SW-XXX Product Change Notification

This PCN applies to all products in the SW-XXX Range

FIGURE 1 - SW-005 REV 4B PCB

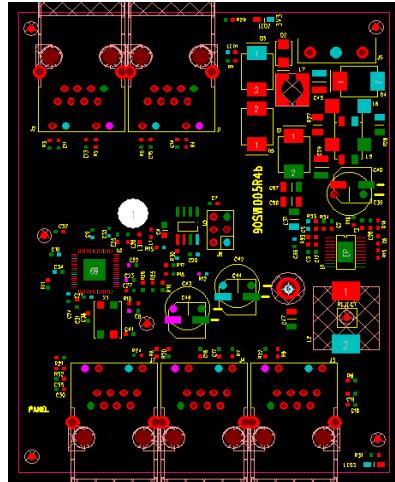
- **Environmental & Manufacturing Improvements:** Brainboxes is an ISO9001/14001 accredited company and we're dedicated to making improvements that help the environment. A design decision to move the LED to the top right, removes the requirement for a plastic pipe reducing environmental impact. This would also allow us in the future to print the case label, to make a further environmental improvement.

- **Design Improvement:** Added extra filtering components to improve EMC performance in harsh industrial environments.
 - **Manufacturing Improvement:** Updated footprint for large inductor (L3) so Production can see solder each side.

- **Customer & Manufacturing Improvements:** Added a tooling hole (as highlighted in white, middle-left on board below). This allows Brainboxes to get a custom base which avoids the lug needing to be manually removed by Production, giving robust case/PCB stability for customers:

FIGURE 2 – SW-005 REV 4D PCB

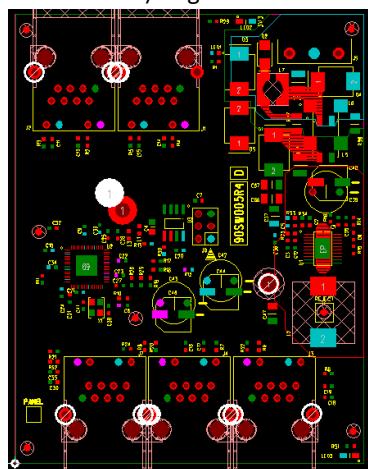
- **Rev 4C:** The following changes have been made (**Rev 4C superseded by Rev 4D on August 8th, 2022**):
 - **Supply:** Due to sudden worldwide obsolescence of the 25MHz crystal in the current 7x5mm package used on the design, we redesigned for a more widely available 3x2 crystal package. This crystal package is expected to be widely available for 10+ years. The functional performance of the Ethernet switch product remains the same.
- **Rev 4D:** The following changes have been made (**Rev 4B & 4D are still in operation due to Note 1 above**):
 - **Customer Improvement:** Added a third mounting hole (as highlighted in white, middle-left on board below) to give more mounting choice to embedded customers:

FIGURE 3 - SW-008 2D DIMENSIONED DRAWING

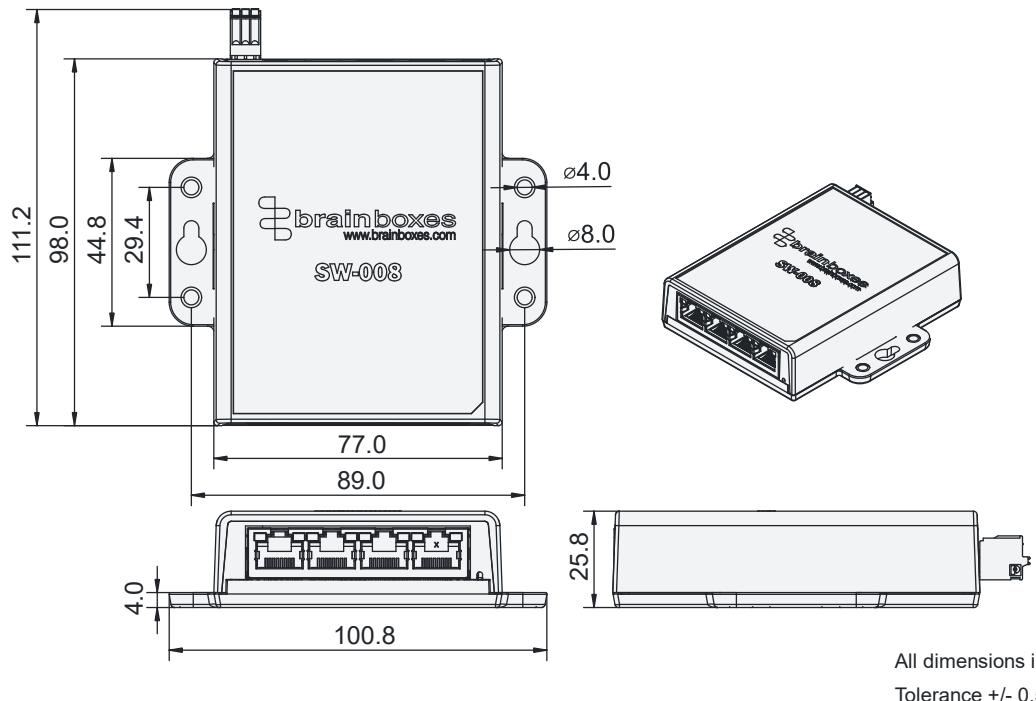
- **Enclosure Dimension Change:** 'Z' (Depth) dimension has been reduced from 27.5mm to 25.8mm ($\pm 0.5\text{mm}$) – See dimensioned drawing below for updated enclosure. No change to 'X' (Width) or 'Y' (Length) dimensions. Datasheet dimensioned drawing updated on: 09/06/25

FIGURE 4 - SW-504 REV 4B PCB

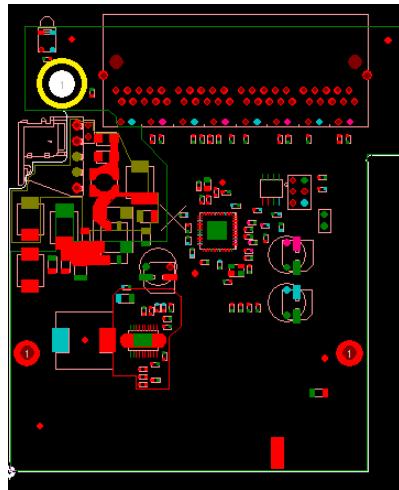
- **Rev 4:** Standard revision – Superseded by Rev 4B on March 1st, 2021.
- **Rev 4B:** The following changes have been made (**Rev 4B is expected to be superseded by Rev 4D on May 1st, 2022. The functional performance of the Ethernet switch product remains the same**):
 - **Design Improvement:** Added extra filtering components to improve EMC performance in harsh industrial environments.
 - **Manufacturing Improvement:** Added a notch in lower board outline for metal case.
 - **Manufacturing Improvement:** Updated footprint for large inductor (L3) so Production can see solder each side.
 - **Customer Improvement:** Added a third mounting hole to give more mounting choice to embedded customers.

**FIGURE 5 - SW-115/515/615XX/715
REV 3C PCB**

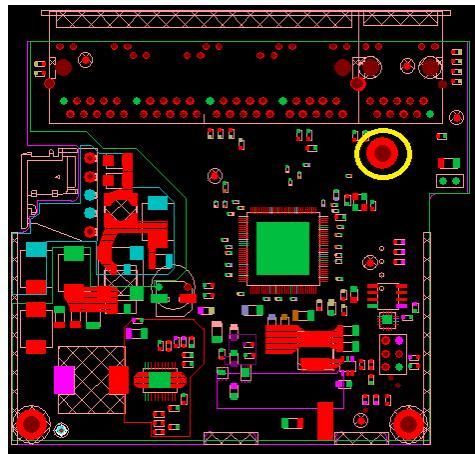
- **Bug Fix:** The Ethernet switch chipset, KSZ9897, has a bug whereby in some scenarios when large amount of traffic is passed between 2 connected Ethernet switches, the switch drops the link and fails to re-establish the lost connection. Rev 3B resolves this issue.

- **Manufacturing Improvement:** Magjack PCB vias have been increased in size to allow for better production.
 - **Customer Improvement:** Added a small microprocessor, which can enable Jumbo Packet support if required.

- **Supply:** Due to sudden worldwide obsolescence of the 25MHz crystal in the current 7x5mm package used on the design, we redesigned for a more widely available 3x2 crystal package. This crystal package is expected to be widely available for 10+ years. The functional performance of the Ethernet switch product remains the same.

- **Customer Improvement:** Added a third mounting hole to give more mounting choice to embedded customers.
